MANDATORY service bulletin

M87-26

SUBJECT: PISTON PIN REPLACEMENT AND THRU BOLT TORQUE CHECK

AFFECTED: TSIO520CE - This engine is used on the Cessna P210 and T210 Aircraft
S/N 530001 through 530140

FIGURE A

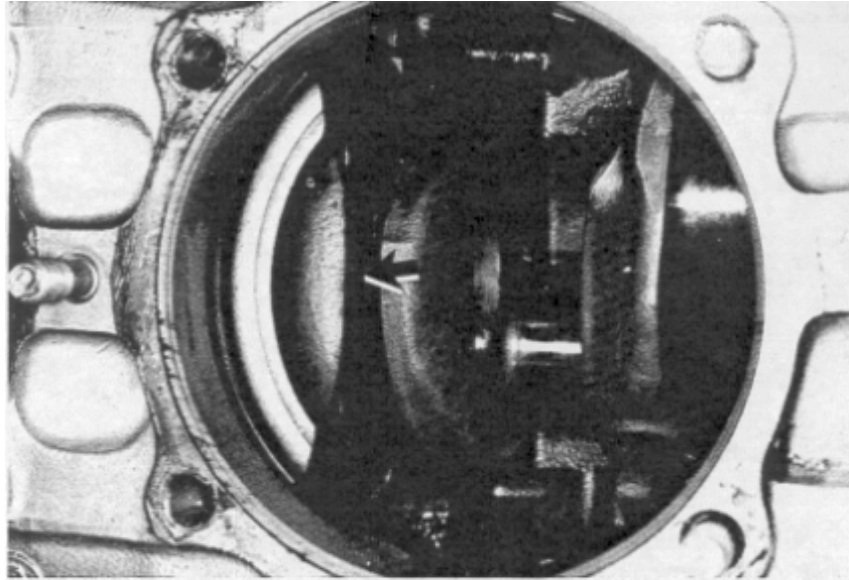
- B. With cylinders and pistons removed, visually inspect the number 1, 2, 3, and 4 crankcase main bearings for any signs of bearing rotation within the case; bearing movement fore or aft within the case or crankcase material distress. Particular attention should be given to number 2 and 3. The crankshaft should be moved fore and aft while performing this inspection. The crankshaft will also require rotation to allow for unobstructed view of the bearings.

Figure A depicts how bearing should generally appear.

Figure B

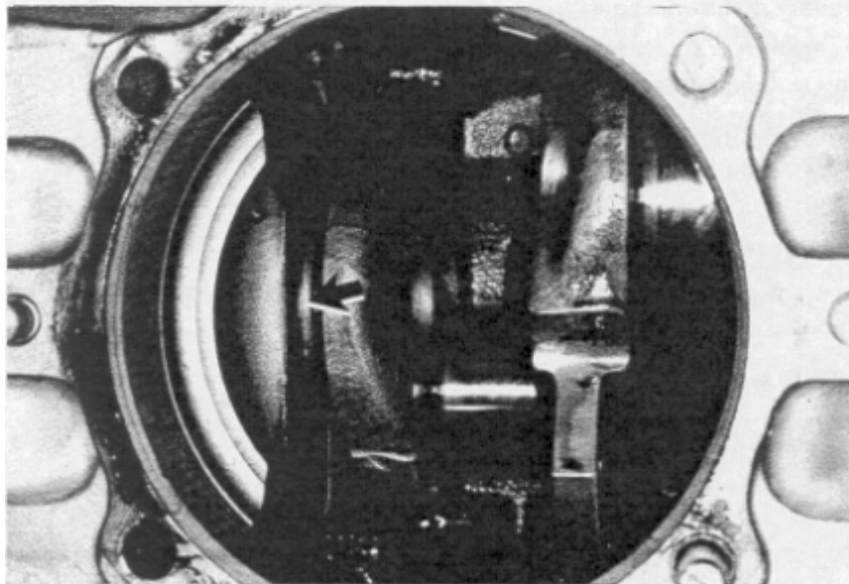
Figure B depicts a bearing that has shifted.

NOTE...Contact your local Teledyne Continental Motors representative (See Page 4) for disposition of any bearing appearing as in Figure B or with any signs of crankcase material distress.

FIGURE C

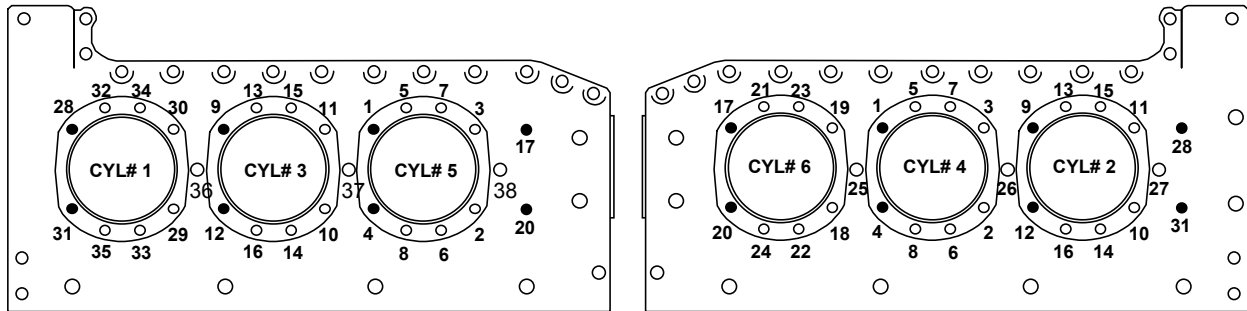
- C. If no problems are detected during the inspection outlined in paragraph IIB, proceed with the installation of new piston pins P/N 630046 and the reassembly of the engine.
- D. The cylinders should be installed in sequence and torqued in sequence per the instructions in Figure C. New cylinder gasket sets should be used, 6 each P/N 646563A1.

CAUTION...Before proceeding note that the six nuts utilized with the seventh stud (positions 25, 26, 27, 36, 37, 38) have a conical seat and can only be used in these positions.

NOTE...Nuts on both ends of thru bolts must be torqued and all studs and thru bolt threads are to be lubricated with clean 50 weight engine oil before installing nuts.

- 1) Install cylinders 4 & 5. Tighten stud nuts (2, 3, 5, 6, 7, 8) and thru bolts (1 & 4) to 300-400 inch lbs. in sequence shown above.
- 2) Install cylinders 2 & 3. Tighten stud nuts (10, 11, 13, 14, 15, 16) and thru bolts (9 & 12) to 300-400 inch lbs. in sequence shown above.
- 3) Install cylinder #6. Tighten stud nuts (18, 19, 21, 22, 23, 24) and thru bolts (17 & 20) to 300-400 inch lbs. in sequence shown above.
- 4) Install cylinder #1. Tighten stud nuts (29, 30, 32, 33, 34, 35) and thru bolts (28 & 31) to 300-400 inch lbs. in sequence shown above.
- 5) Install 7th stud brackets & nuts (25, 26, 27, 36, 37, 38) and tighten to 300-400 inch lbs. (See Caution above).
- 6) Finish torquing thru bolts and stud nuts to their final torque values in sequence shown above.

INCH LBS.
Thru Bolts	1, 4, 9, 12, 17, 20, 28, 31	690-710
Stud Nuts	2, 3, 5, 6, 7, 8, 10, 11, 13 Thru 16, 18, 19, 21 Thru 27, 29, 30, 32, Thru 38	490-510

NOTE...Repeat torquing sequence with final torque values to insure that all thru bolts and stud nuts have been torqued.
